**BIG HORN COAL COMPANY
10980 SOUTH JORDAN GATEWAY
SOUTH JORDAN, UT 84095**

April 23, 2020

RE: Objections to Proposed Brook Mine Permit Application, Sheridan County, Wyoming

Big Horn Coal Company 10980 South Jordan Gateway South Jordan, UT 84095	
ATTACHMENT 1	
Sheridan County, Wyoming State Plane NAD 83 WYCC	
Drawn By: J. Sweezy	Scale: 1:18,000
Approved By:	Date: 4/21/2020
Revision:	Draw No.:
BHCC_Attachment_1

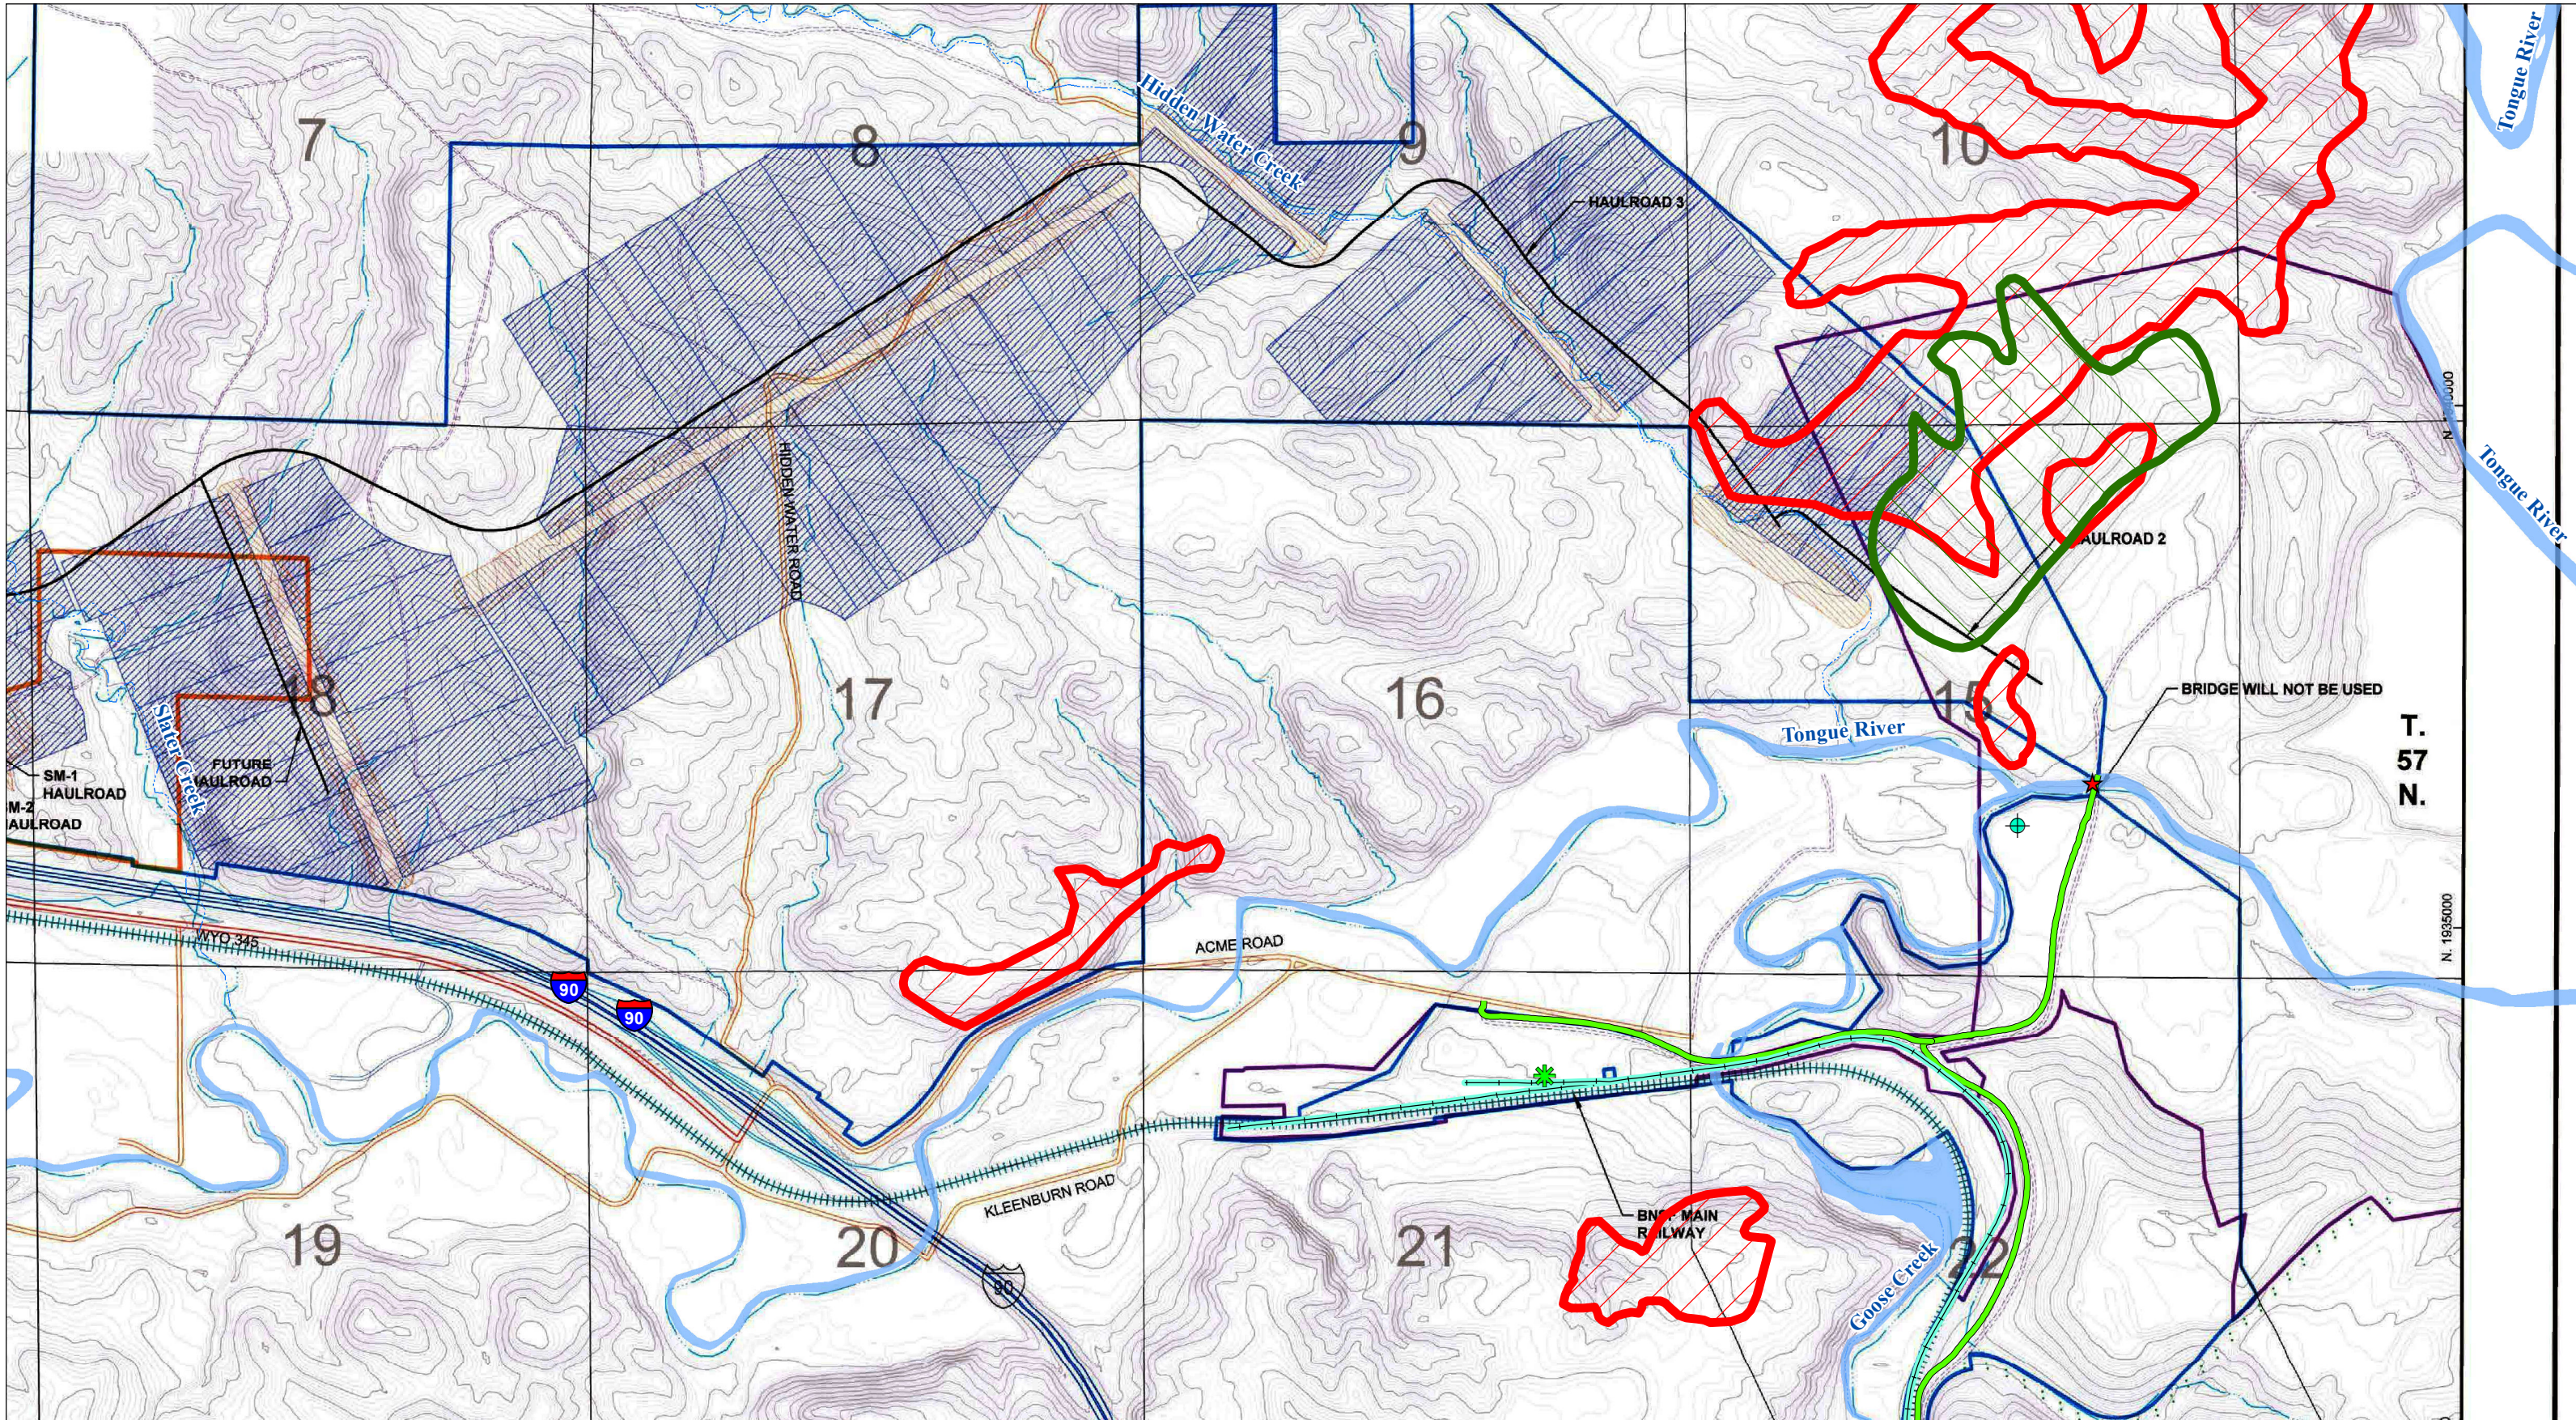
The fire control plan referenced in Section MP.11 and presented in Addendum MP-5 describes measures to be taken to prevent and control fires in the mine pits, fires in the mine's processing and shop facilities, equipment fires and rangeland fires. BHCC objects, however to the proposed Mine Plan and Addendum MP-5 not providing plans to control and extinguish new subsurface coal fires that may develop or existing subsurface coal fires that may become rekindled or enlarged as a result of the highwall mining panels that will be opened outboard of the highwall trench openings.

Attachment 1 provided with this Objection No. 4 is a drawing showing the approximate extent of underground coal mine fires in the area of proposed highwall mining in Sections 10 and 15, T57N, R84W, as reported by the U.S. Geological Survey in 1980. The fires in this particular area originated with mining of the Monarch coal seam. This and other nearby historic underground mines have long been known to exhibit numerous subsidence features and underground coal mine fires, and in the late 1980s BHCC received approval from the WDEQ/LQD to permanently place nearly 10 million bank cubic yards of overburden over the area shown on Attachment 1 in an attempt to reclaim the subsidence and control the fire. That unique reclamation feature is known as the Pit 3 Subsidence Dump in Big Horn Mine's reclamation history. The proposed highwall mining will develop mine openings in the Carney and Masters coal seams beneath the Monarch seam in areas that are known to still exhibit evidence of underground coal fires. Plumes of steam and smoke have been observed again over the general area of Sections 10 and 15 this winter of 2016-2017. These observations indicate that, in certain places, the perimeter of the historic subsurface coal seam fires has expanded notable distances from the referenced 1980 boundary delineation.
